**Open Report on behalf of Andy Gutherson - Executive Director for Place**

Report to:	<b>Planning and Regulation Committee</b>
Date:	<b>2 October 2023</b>
Subject:	<b>Application by Cottam Solar for a Development Consent Order to install solar PV panels to generate 530MW, on site battery storage with 600MW/h capacity and associated infrastructure including battery energy storage system, access provision and an underground 400kV electrical connection to the National Grid Substation at Cottam Power Station.</b>

**Figure 7.11**  
Cottam 1  
Augmented ZTV

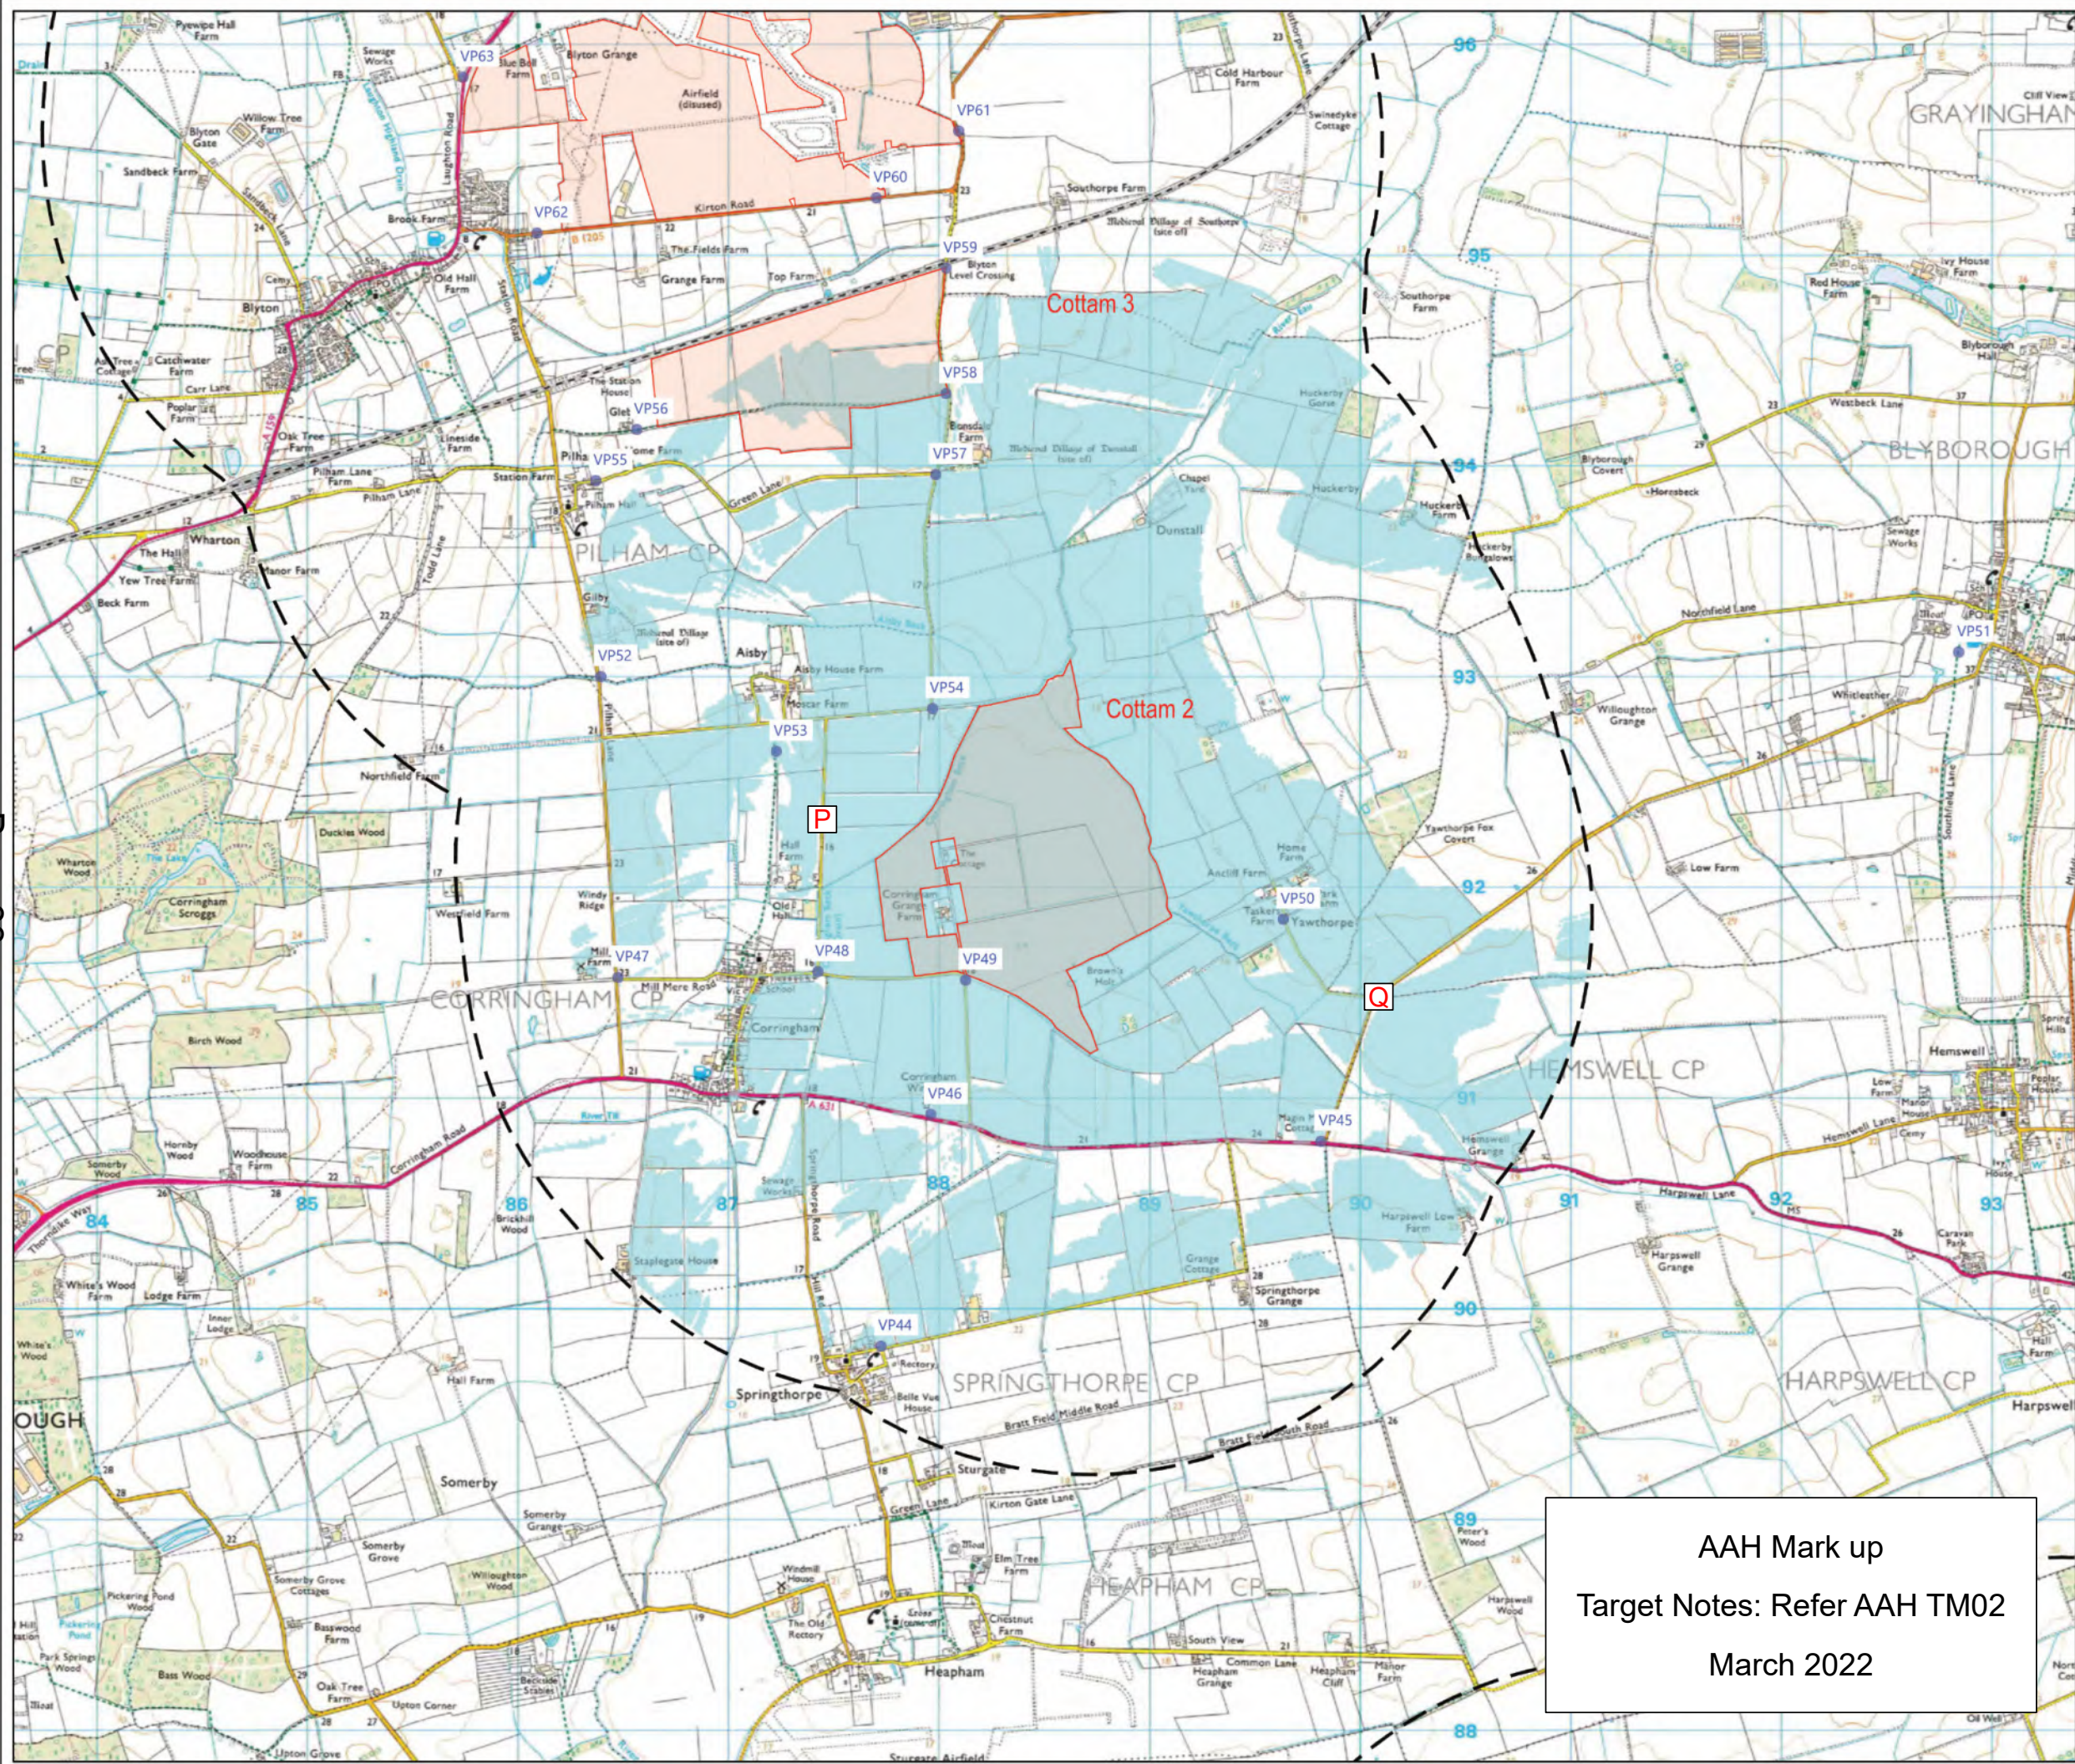
As shown on mark up Figure 7.11 Cottam 1 Augmented ZTV

**Figure 7.12**  
Cottam 2  
Augmented ZTV

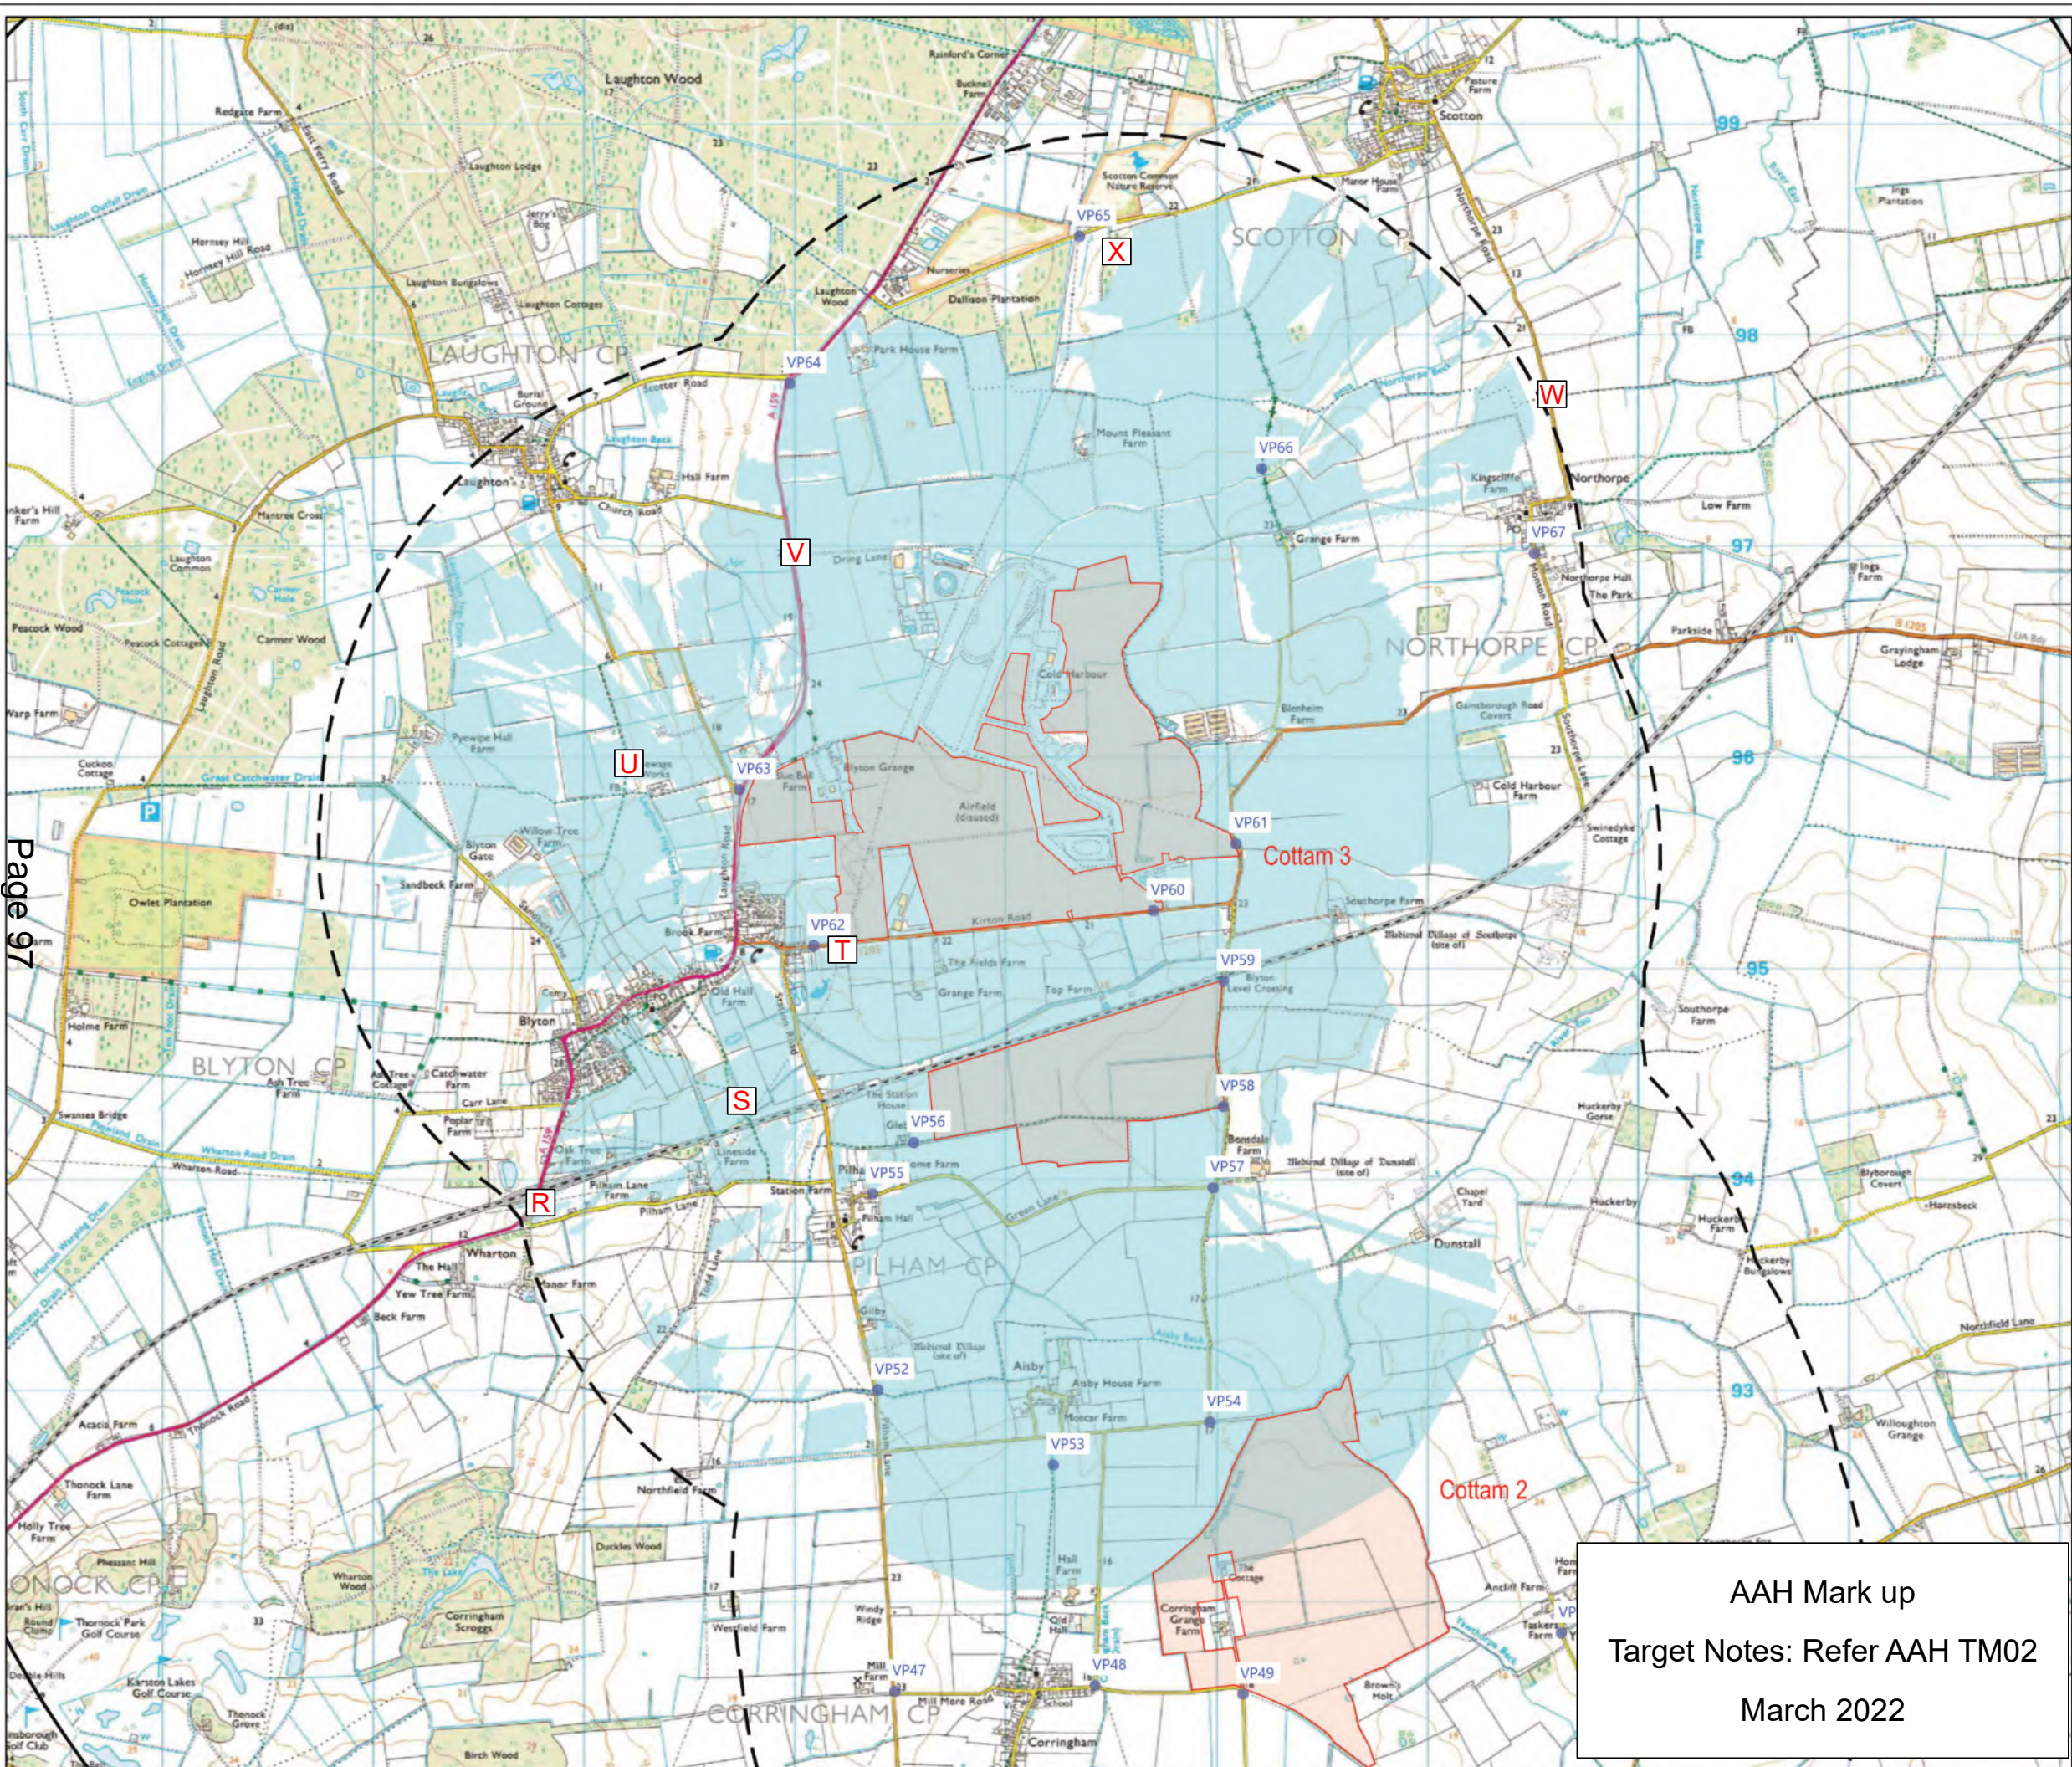
As shown on mark up Figure 7.12 Cottam 2 Augmented ZTV

AAH Mark up  
Target Notes: Refer AAH TM02  
March 2022
